CHANGE ORDER #3

Project: #1258.004 - DAHL ARTS CENTER
REMODEL AND ADDITION
Rapid City, South Dakota

Change Order No.: 3**Initiation Date:** September 14, 2007

SHEET
MS-1
REF SHEET:
M15-42

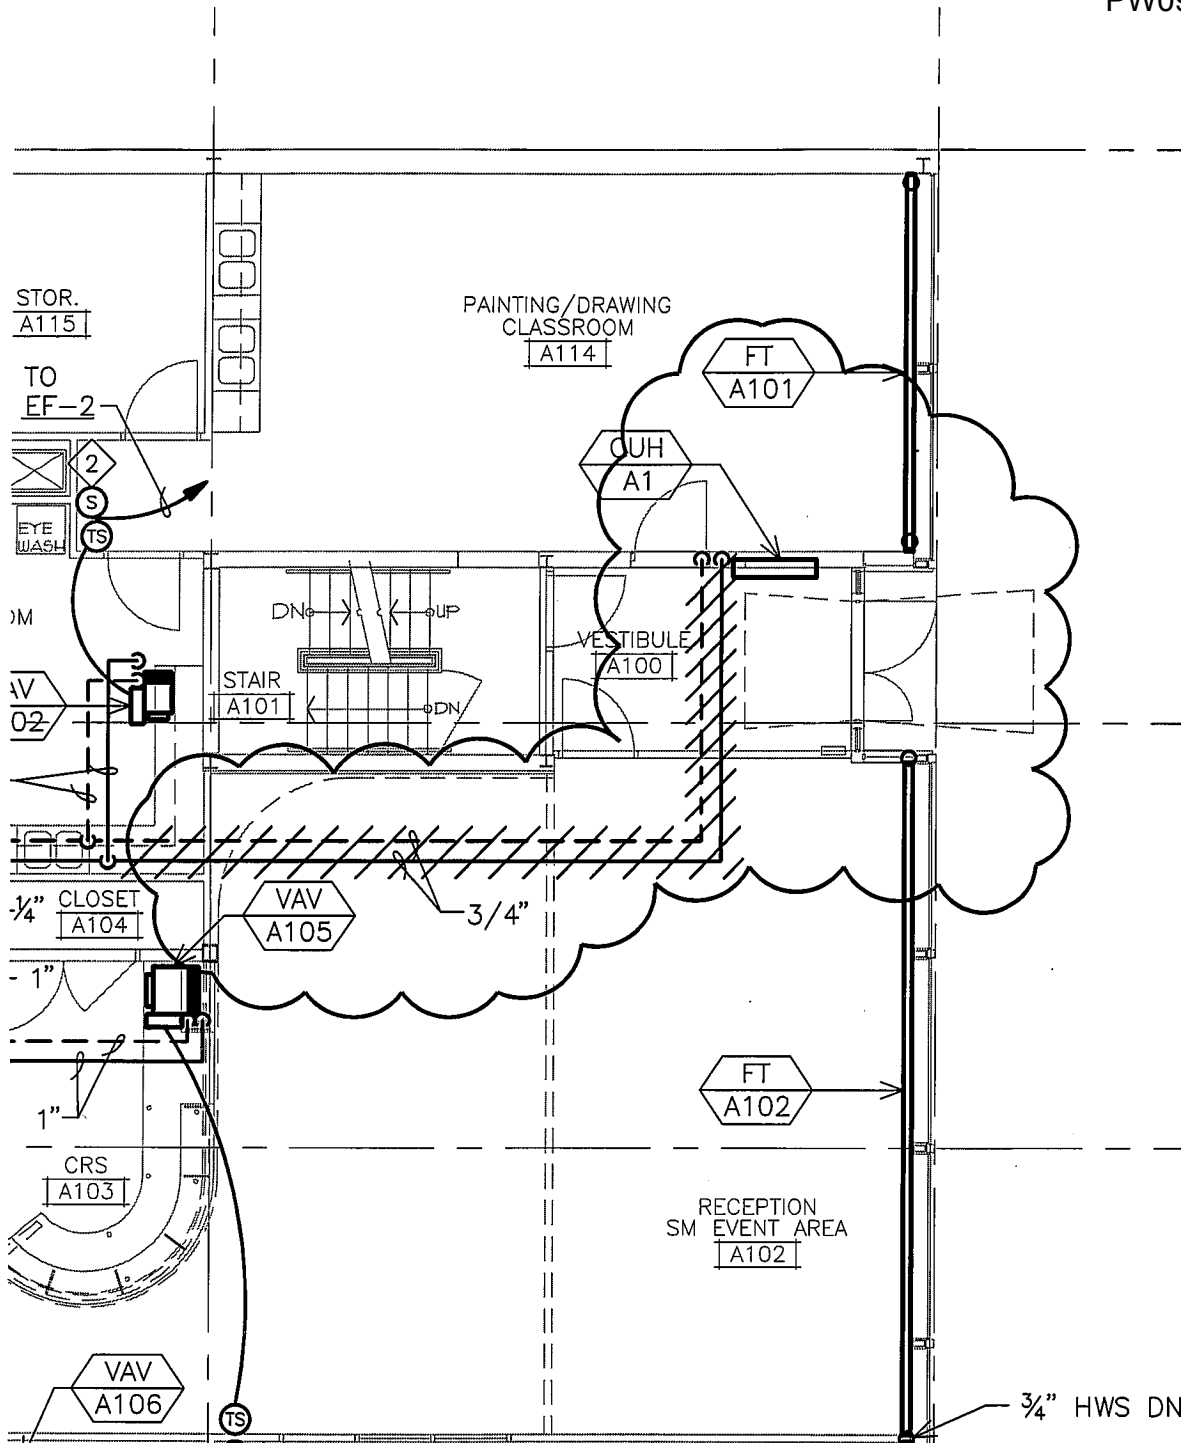
1. Delete HWS/HWR piping as shown on MS-1. Note that this piping was reduced to 3/4" size under ASI#1.
2. Add HWS/HWR piping in basement to supply CUH-A1 as shown on MS-2. Note that there is an existing pipe sleeve that indicates there will not be a conflict with the beam below (see photo).

Note that we anticipate a credit of approximately 60 linear feet of piping including insulation, pipe hangers, etc. with this change.
